**Re: Initial Submission Review: Parklands Village 1 Phase 2 – Site Plan and Plat**  
**Application Number: DA-2289-06**  
**Case Numbers: 2024-4015-00; 2024-3028-00**

## Initial Submission Review

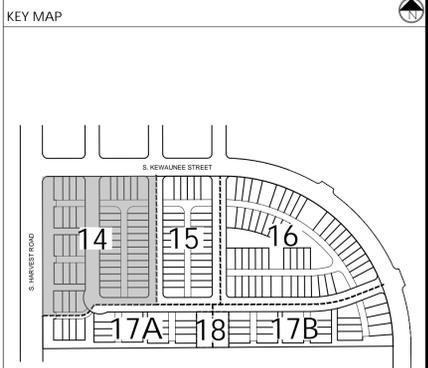
Believe stop sign at this location. Trees need to be 50' away from regulatory signs.

Per the Plat, this is called South Irvington Street Typ.  
**RESPONSE: UPDATED STREET NAME TO E. HAWAII AVE. PER CITY DESIGNATION**

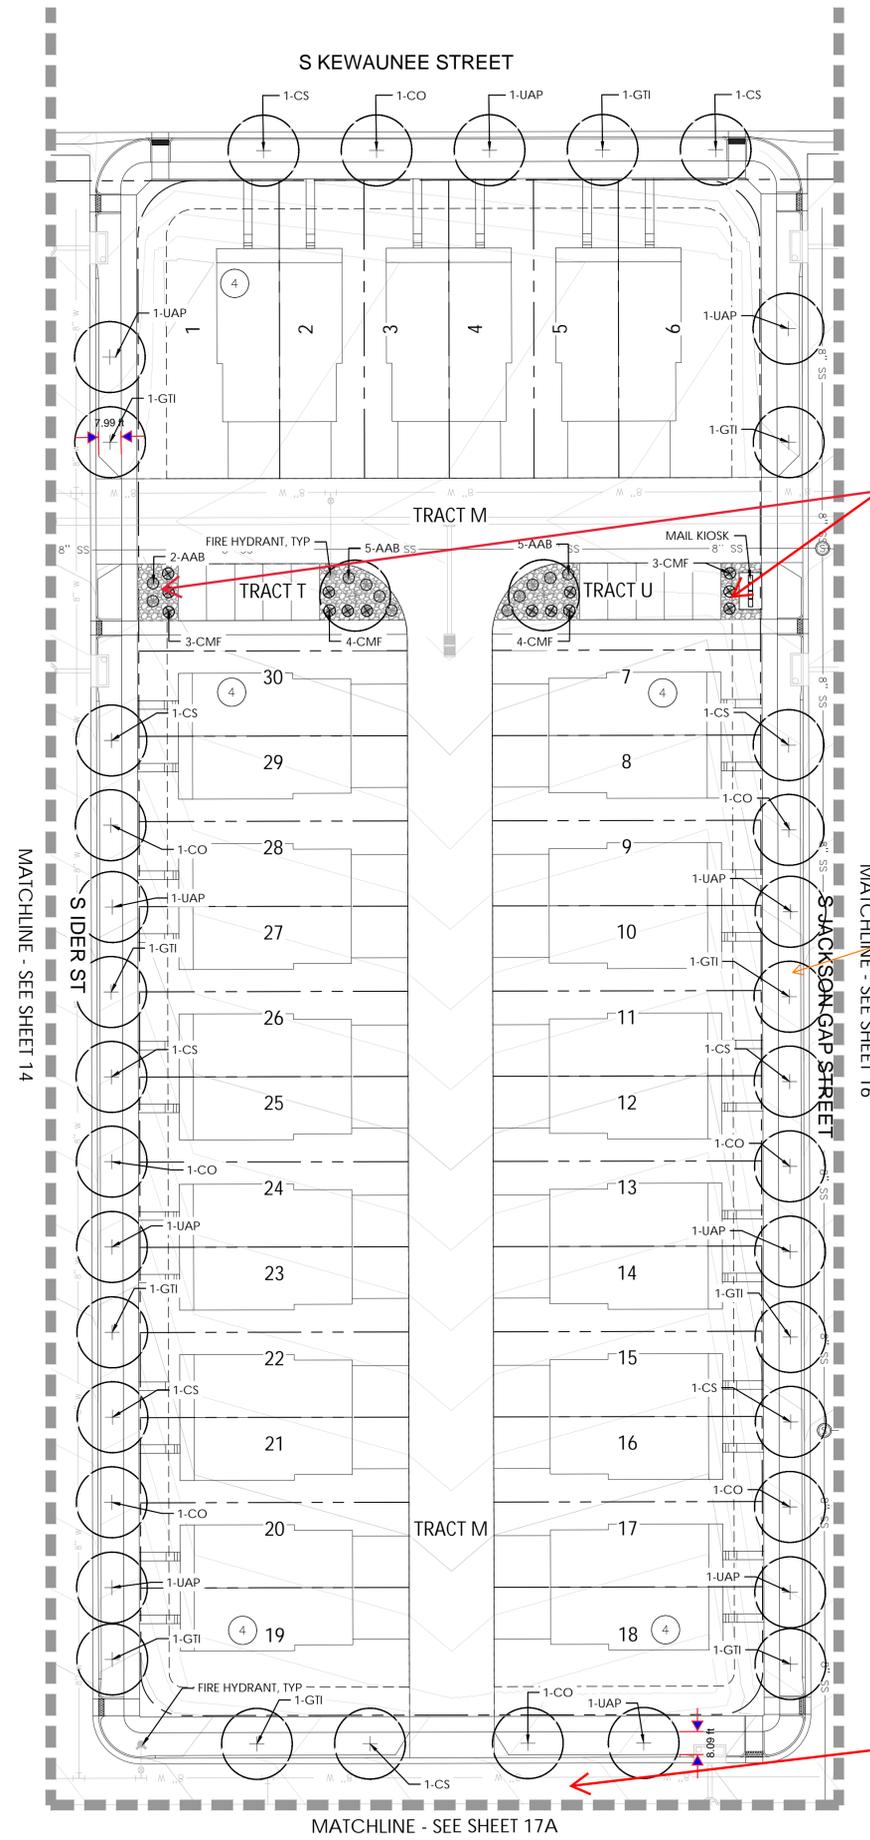
Refer to Sheet 19, Detail 7 for monument sign  
**RESPONSE: ADDED LABEL**

Provide the curbside landscaping along this perimeter and call out the Project name and screen back the planting. Also include the CNr  
**RESPONSE: ADDED**

add dimensions  
**RESPONSE: ADDED**

**RESPONSE: CURBSIDE LANDSCAPE FOR ADJACENT DEVELOPMENT HAS NOT BEEN PROVIDED YET.**

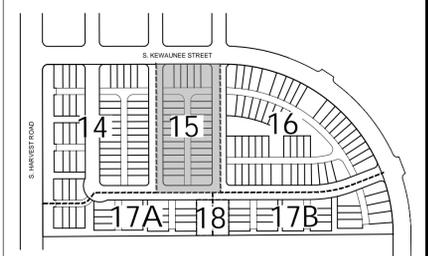
Pedestrian crossing. Trees 50' from crossing.  
 RESPONSE: REVISED

RESPONSE: REVISED STREET NAME

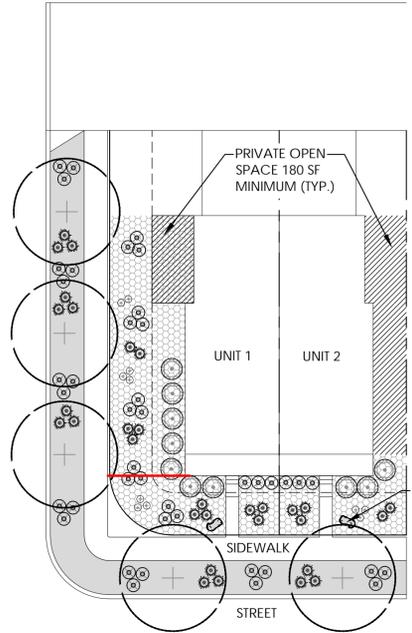
Provide labels on these units, typ.

RESPONSE: ADDED

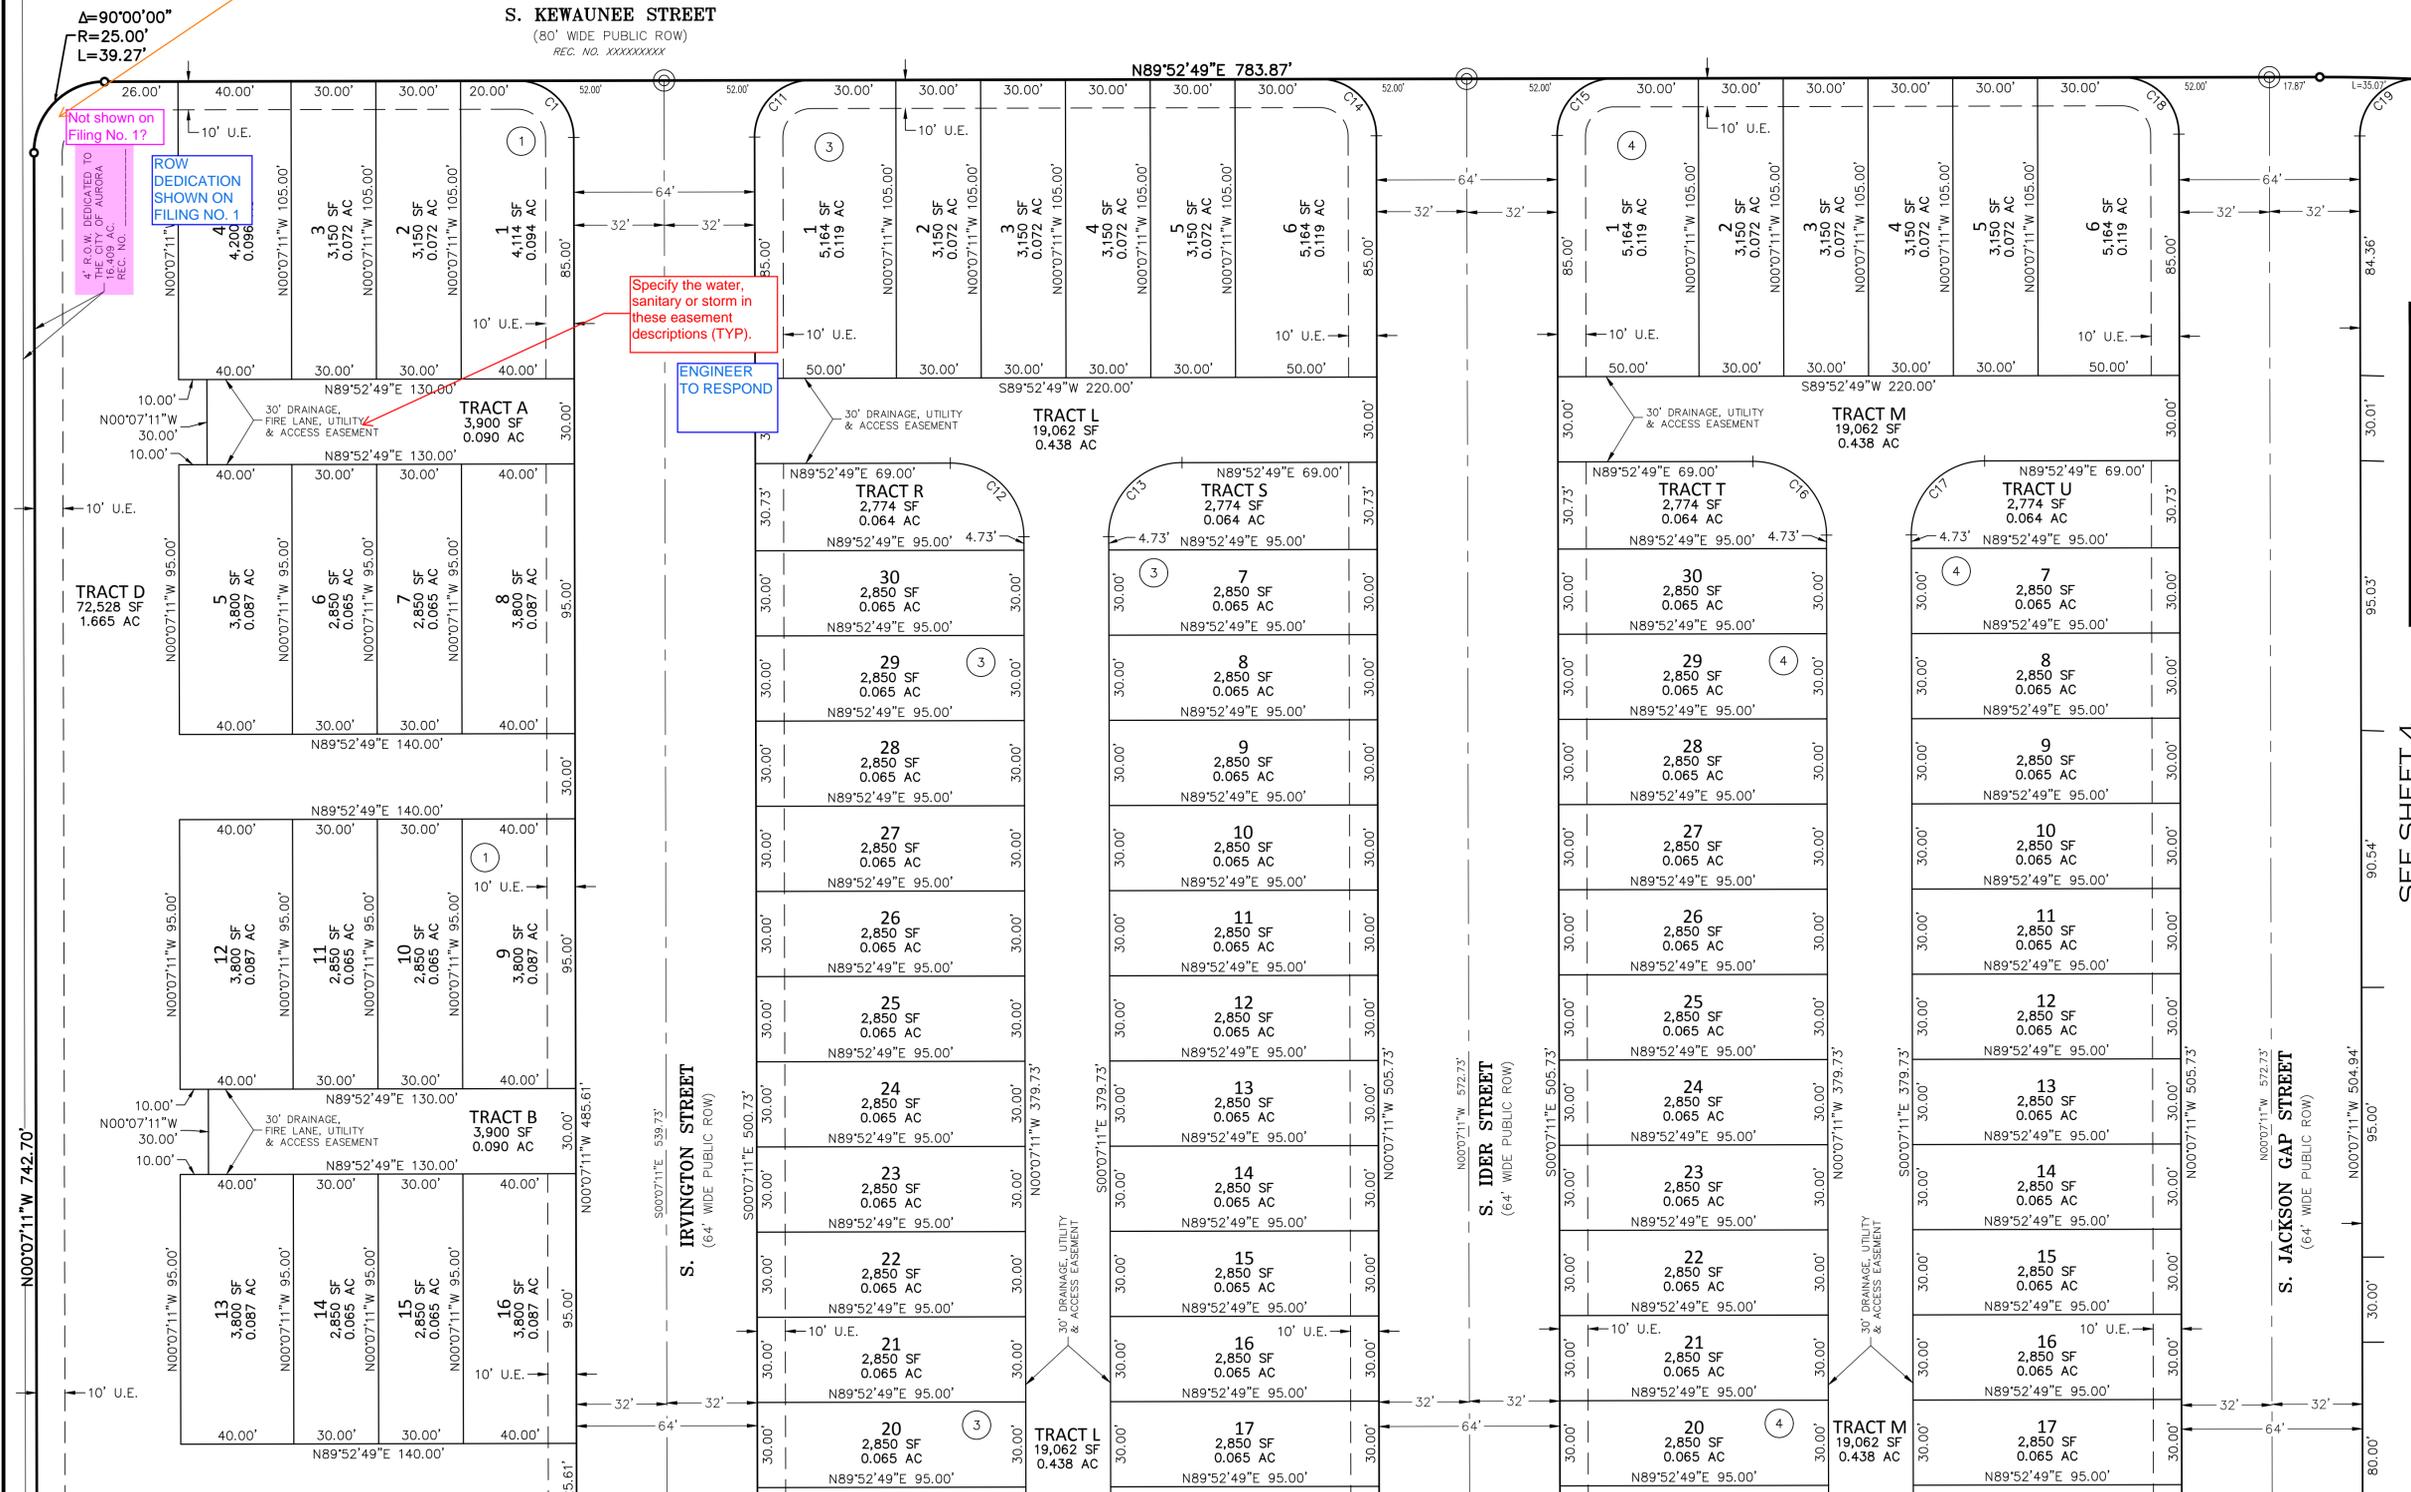
To permit maintenance of the proposed traffic signal equipment (such as controller cabinets, pull boxes, and signal poles), dedicate a traffic signal easement (consisting of a 75-ft corner chamfer from the intersection of flowlines)

Show opposing ROW per COA 2024  
Subdivision Plat Checklist Item #14.

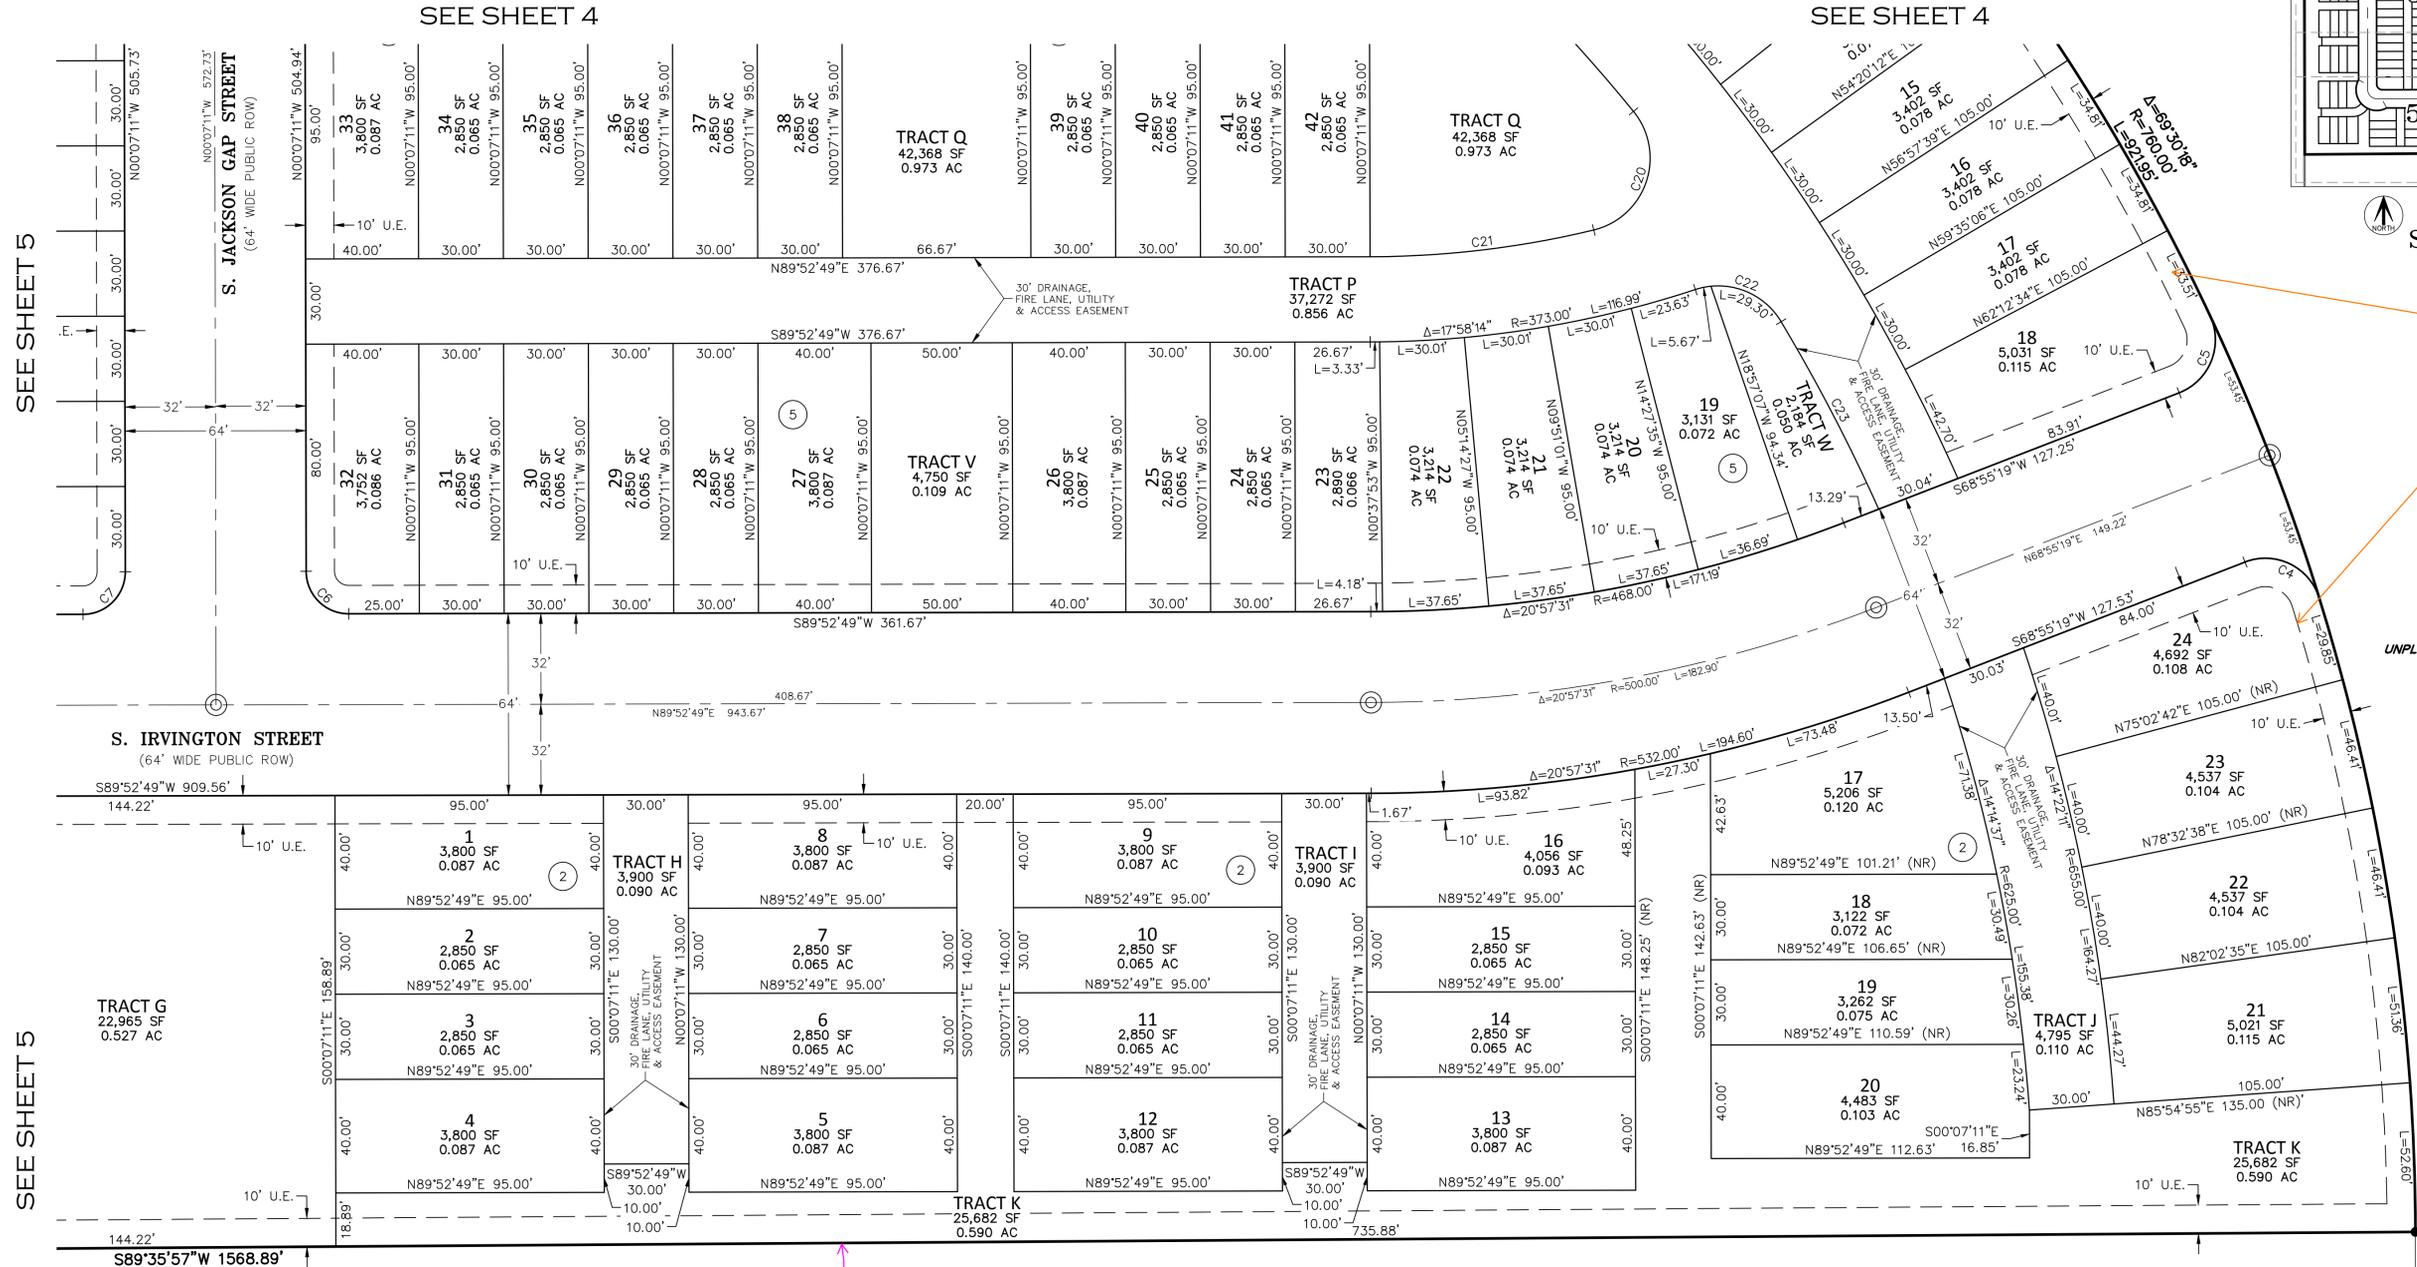
sight easement see Site plan  
LINE WORK TO BE PROVIDED BY ENGINEER

Monuments must be set no more than 1400' apart along any straight boundary line per COA 2024 Subdivision Plat Checklist 13.d.(3)

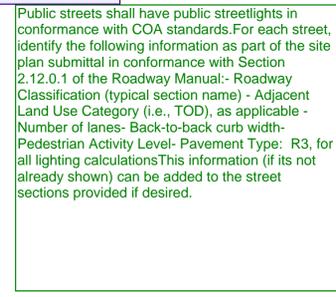
entire width is paved? 1. what is required FL width? We prefer not to have 30' of paved alley. 2. do all alleys have fire lane? 3. Reduce access easement and alley width where utilities are provided from the street.

Alleys updated to be 26' cross-section updated as needed.
